Balboa Park Central Mesa

Precise Plan

Proposed Amendment for
Plaza de Panama, Circulation, and a Parking Structure

April 5, 2012
Sixth Draft

Central Mesa Study Area

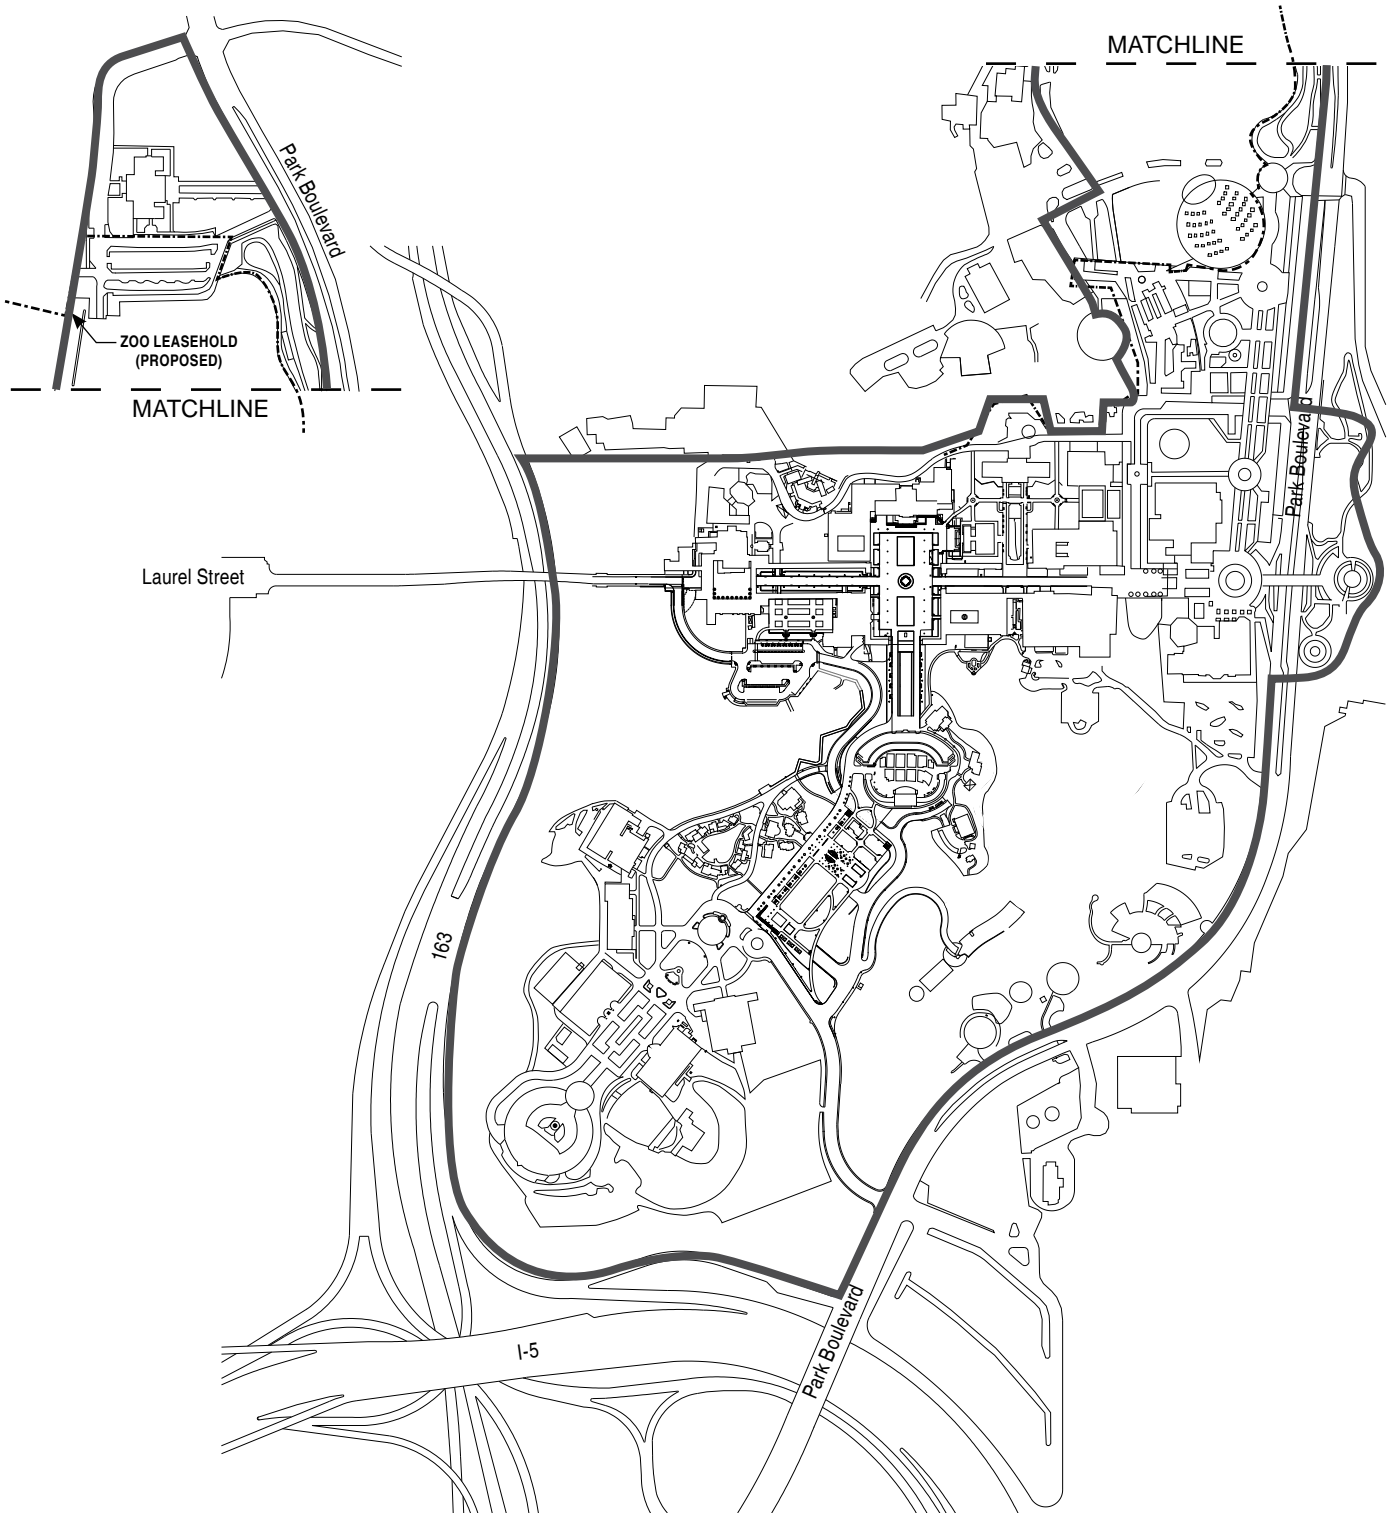
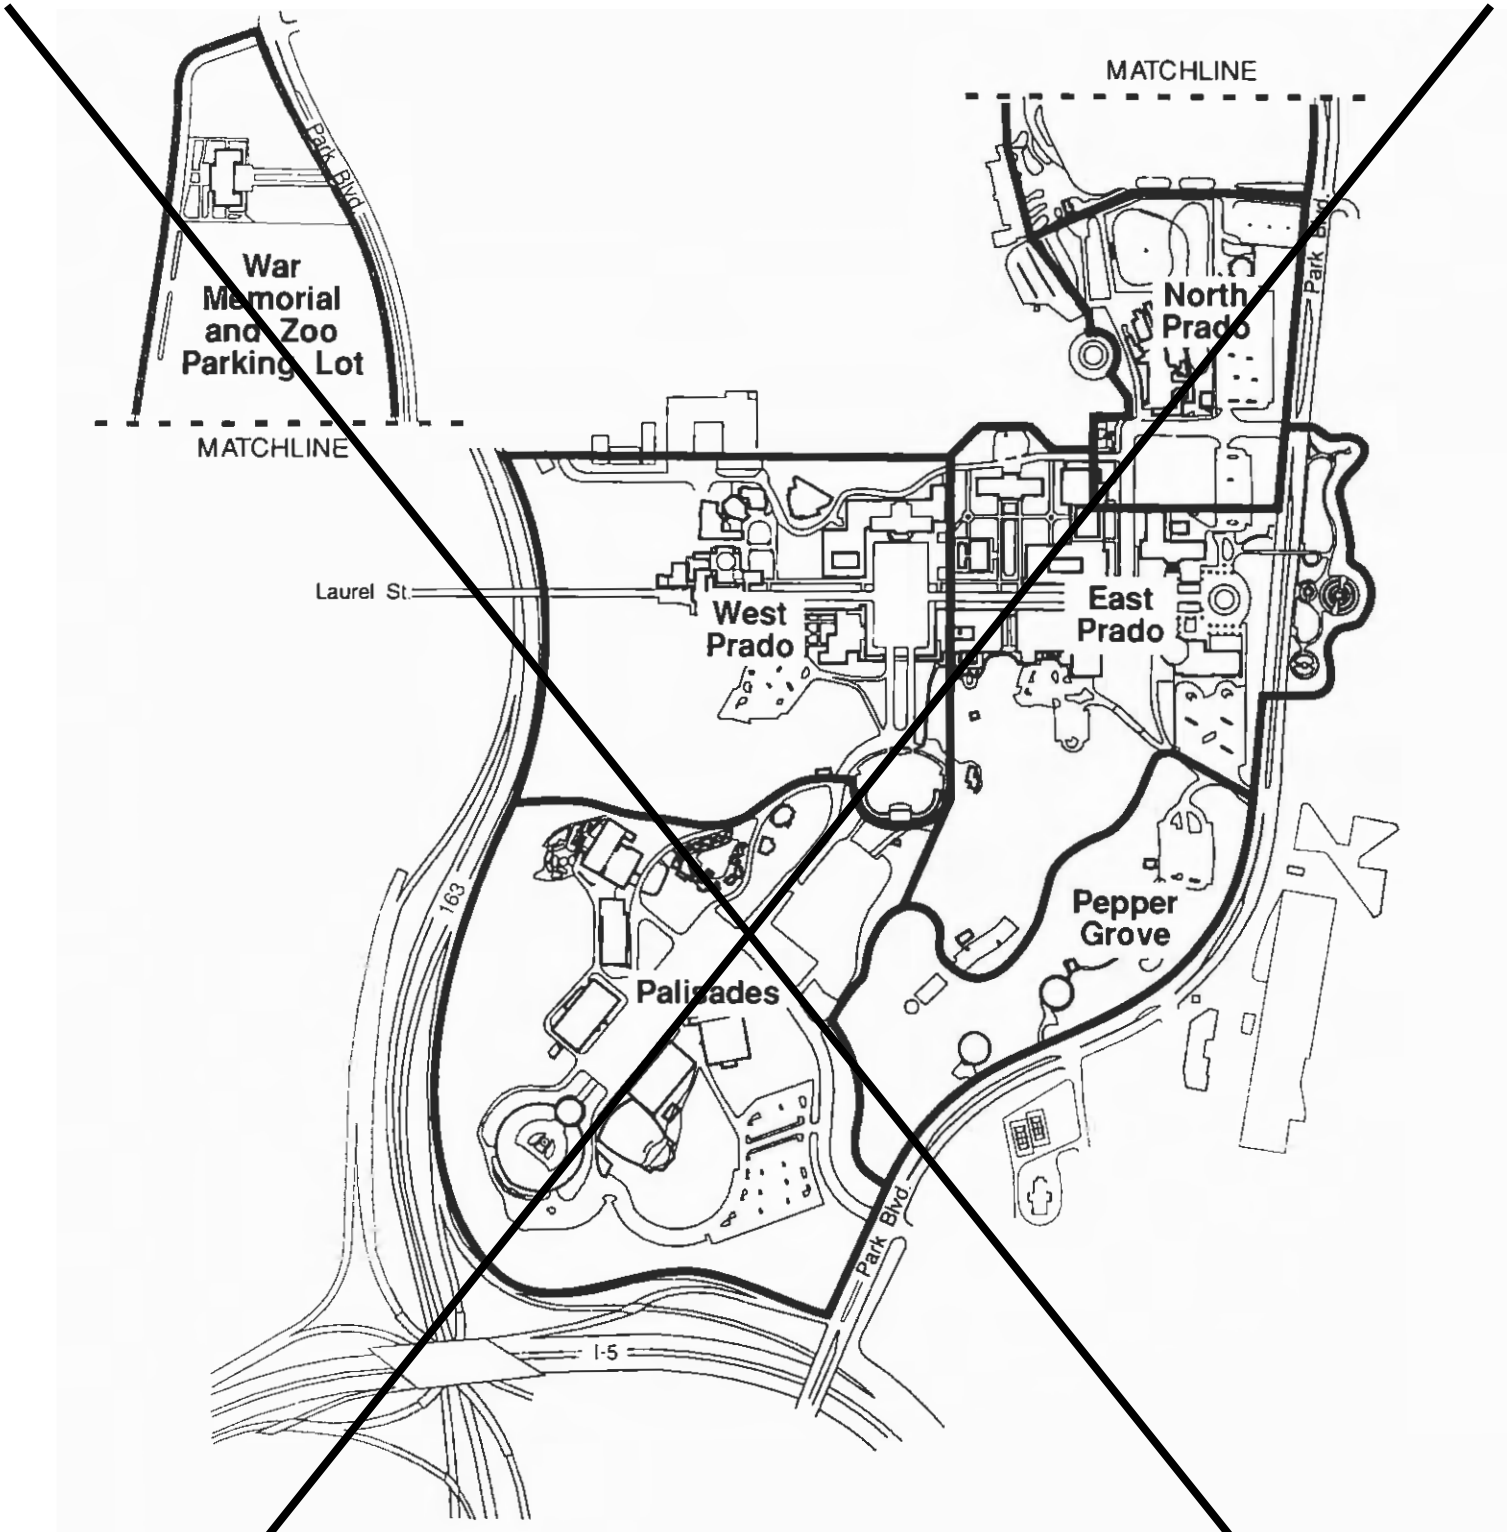
revised 5 April 2012

Central Mesa Subareas

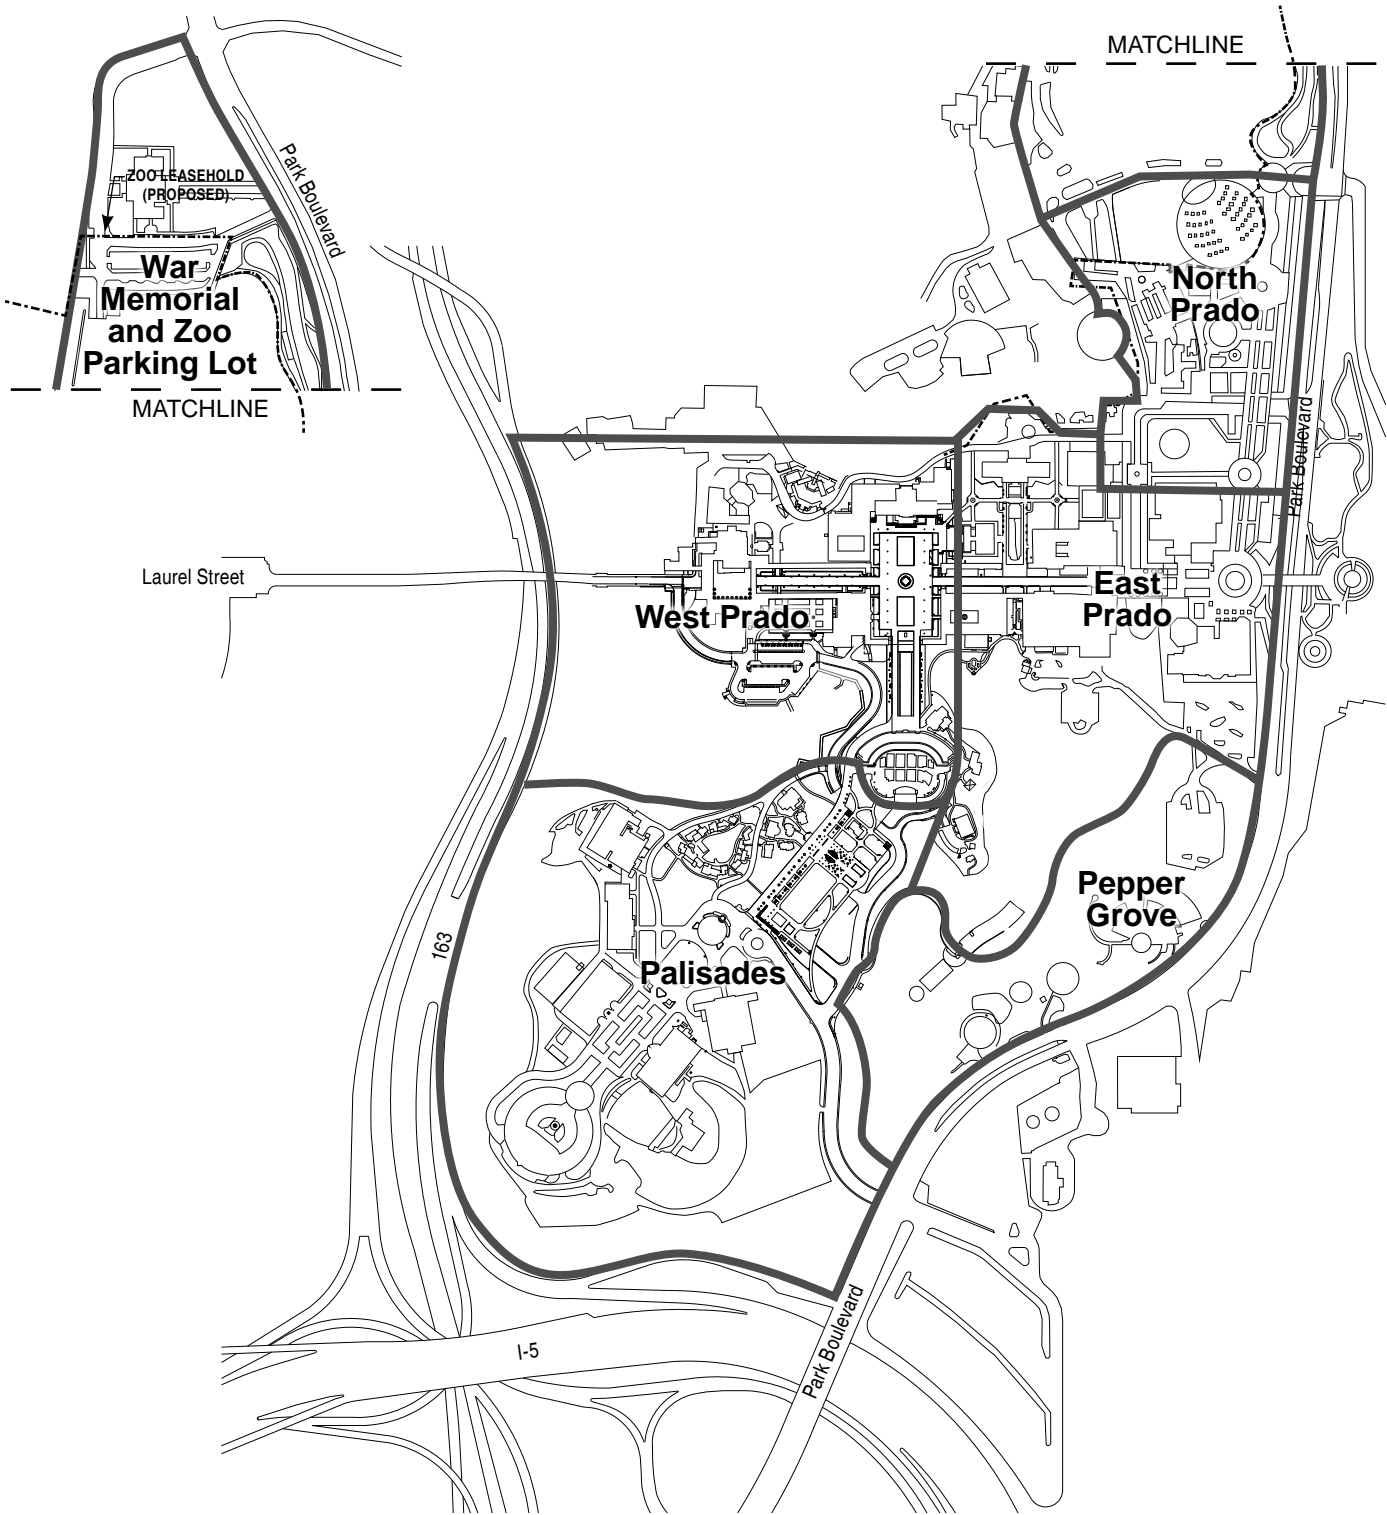
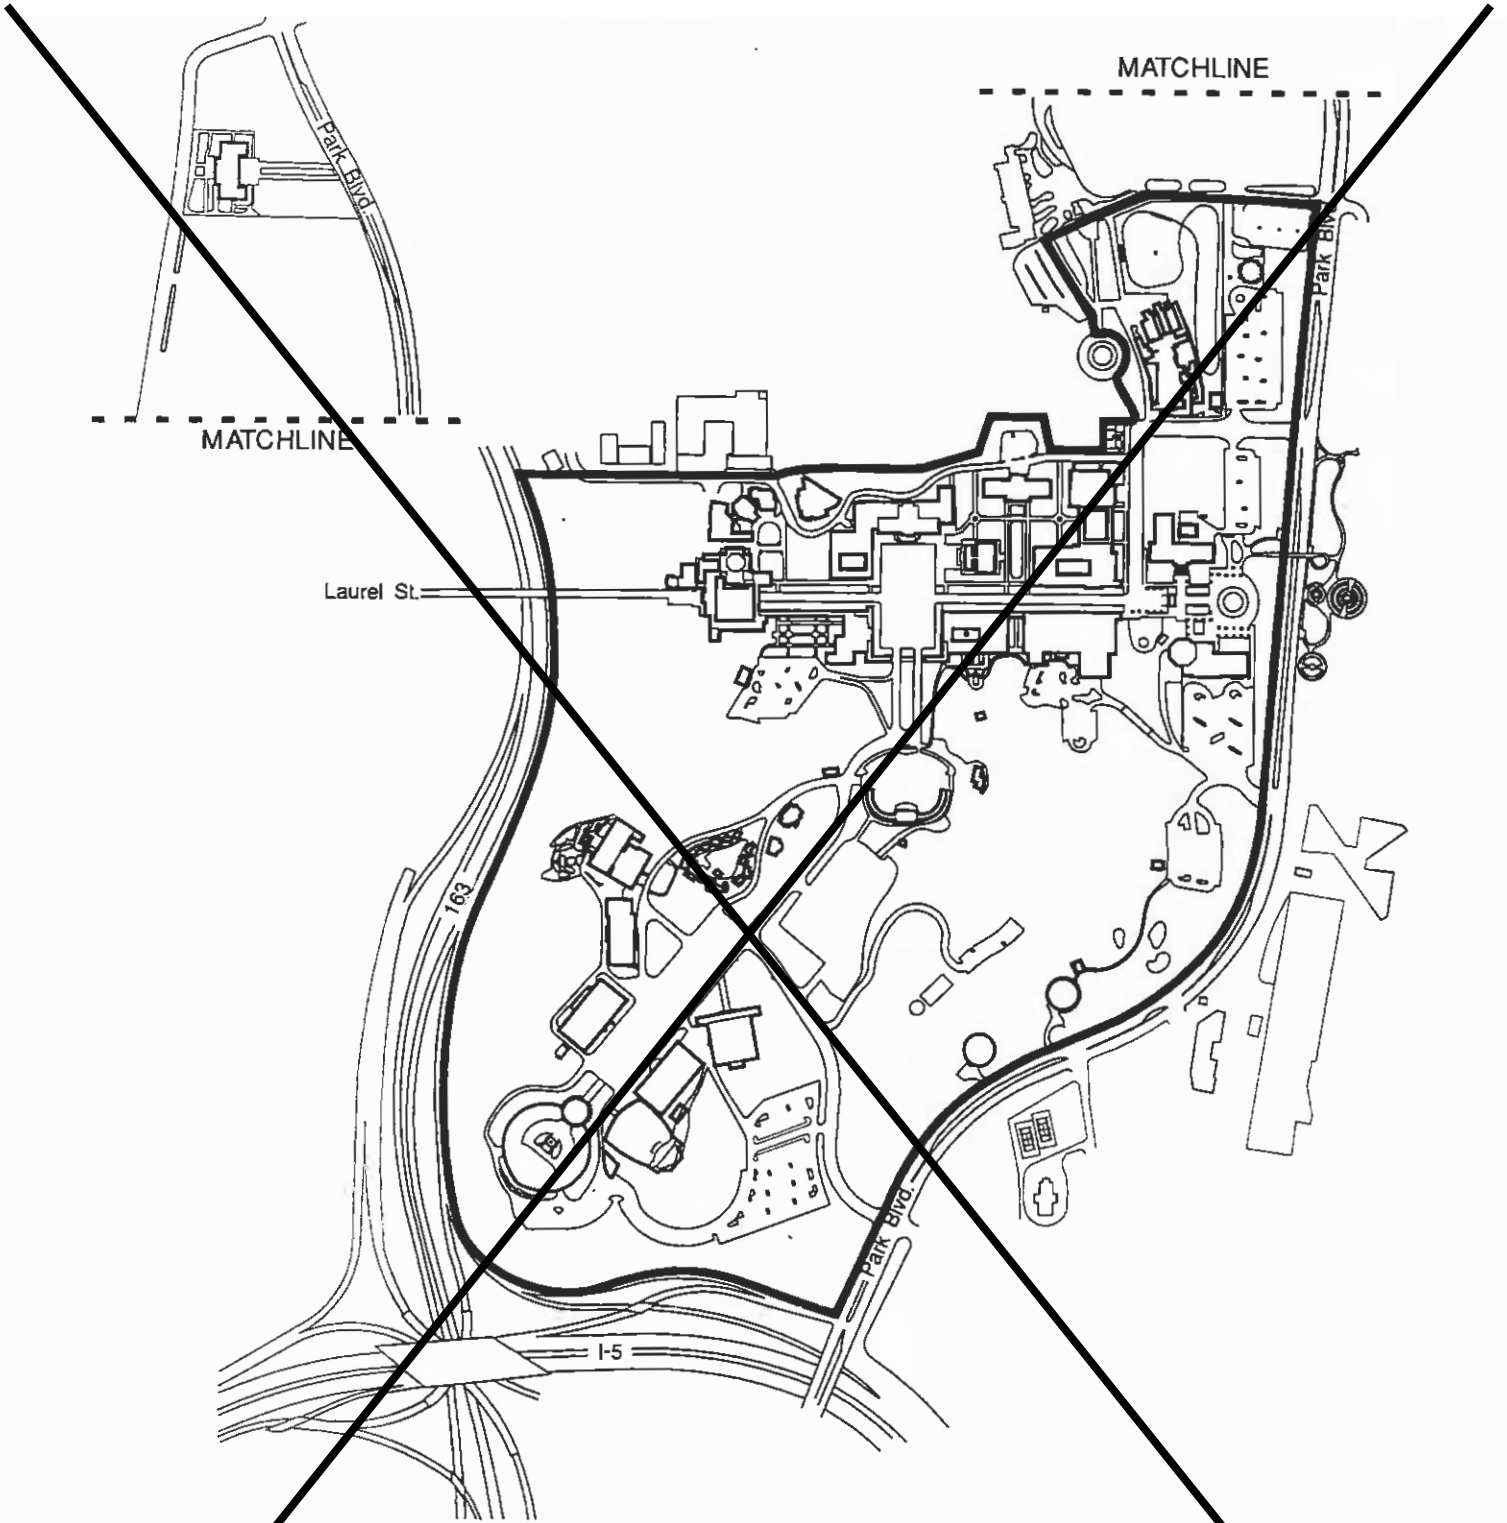
revised 5 April 2012
